## REVISED RESPONSE TO REQUEST FOR ADDITIONAL INFORMATION

### APR1400 Design Certification

Docket No. 52-046

**RAI No.:** 269-8319  
**SRP Section:** 09.02.02 – Reactor Auxiliary Cooling Water System  
**Application Section:** 09.02.07  
**Date of RAI Issue:** 10/22/2015

Figure 9.2.7-1 Essential Chilled Water System Flow Diagram (Sheet 2 of 4)

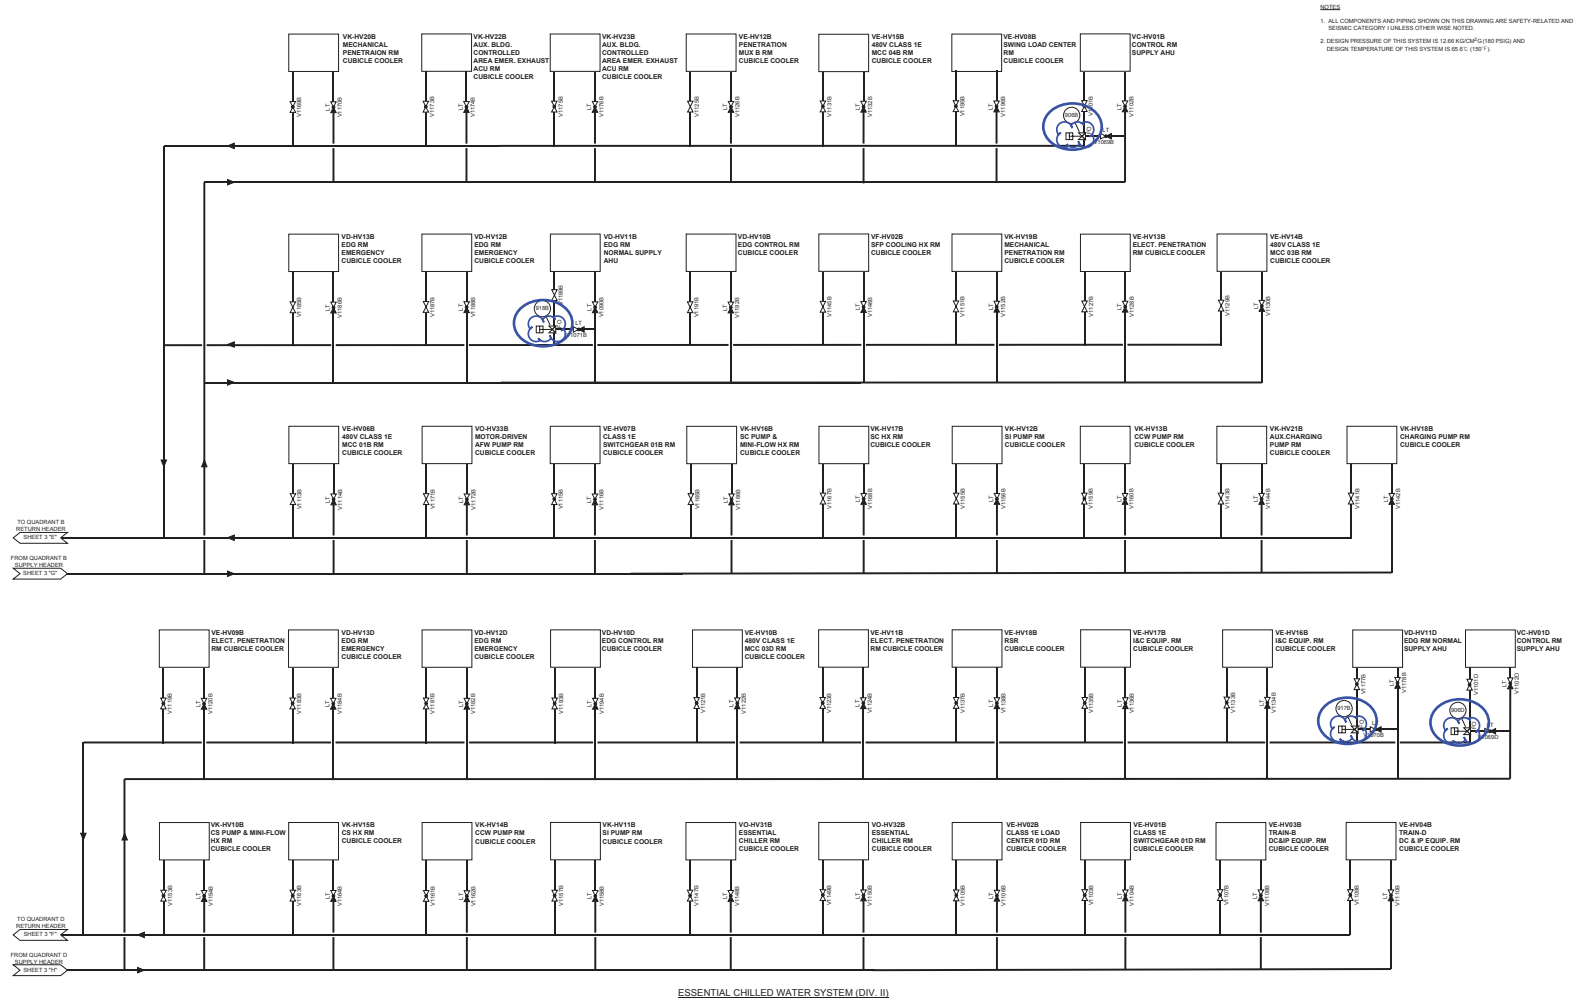
- a) Nominal pipe sizes are not shown on the DCD Tier 2, Section 9.2.7, figures and the system description does not explain the criteria that are used for establishing the appropriate pipe sizes (e.g. limiting flow velocities).

- b) Filters or strainers are not shown in the DCD Tier 2, Section 9.2.7 figures and DCD Tier 2, Section 9.2.7, does not discuss how particulate and other foreign material will be controlled in the system.

- c) SRP 9.2.2 specifies that essential components and subsystems can function as required in a loss of offsite power and instrument air systems. DCD Tier 2 describes the ECW control valves as air-operated three-way control valves that fail open upon a loss of control signal or electrical power. However, the DCD does not discuss or evaluate the impact the ECW control vales have on the system when they fail closed due to loss of instrument air.

- a) Figure 9.2.7-1 is a simplified flow diagram; therefore, nominal pipe sizes are not shown. The pipe in the essential chilled water system is sized in accordance with engineering practices that determine appropriate pipe size to limit chilled water velocity in the pipe to below the design guideline velocity.

- b) Strainers are installed in the construction phase and removed prior to plant operation. The essential chilled water system is a closed-loop system, and impurities cannot infiltrate into the system. The essential chilled water system is filled and circulated with clean demineralized water; therefore, a filter or strainer is not required or provided in the system during plant operation and is not shown in Figure 9.2.7-1.

- c) The ECW control valves are air-operated three-way valves that are designed to be fail open upon loss of instrument air. DCD Tier 2, Subsection 9.2.7.2.1 will be revised to indicate that the ECW control valves are fail open upon loss of instrument air and DCD Tier 2, Figure 9.2.7-1 will be revised to change the symbol of the ECW control valves to be consistent with the symbol used as fail open for control valves in DCD Tier 2, Figure 1.7-1.

Figure 9.2.7-1 Essential Chilled Water System Flow Diagram (Sheet 1 of 4)

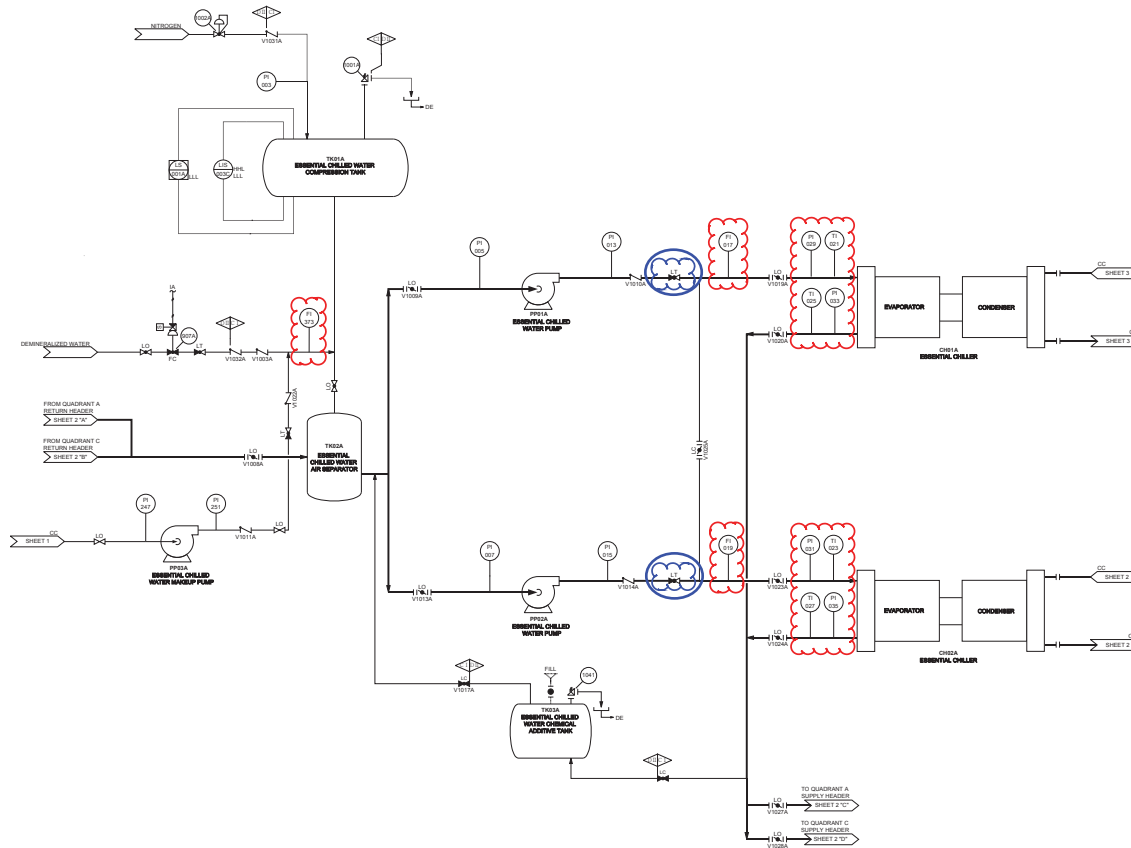
- a) All portions of the ECWS are accessible in the auxiliary building
- b) The current design allows for component maintenance due to the absence of isolation/maintenance valves.

- b) Isolation valves are provided on the inlet and outlet of components such as essential chillers and essential chilled water pumps to provide component isolation during component maintenance. Butterfly valves are provided on the inlet and outlet of the essential chillers as shown in Figure 9.2.7-1. And a butterfly valve is provided on the suction side of each essential chilled water pump and a globe valve is provided on the discharge side of each essential chilled water pump. However, the globe valves are not currently shown in Figure 9.2.7-1. Figure 9.2.7-1 will be revised to add a globe valve on the discharge side of each essential chilled water pump. The existence of isolation valves will not be described additionally in the DCD.
-
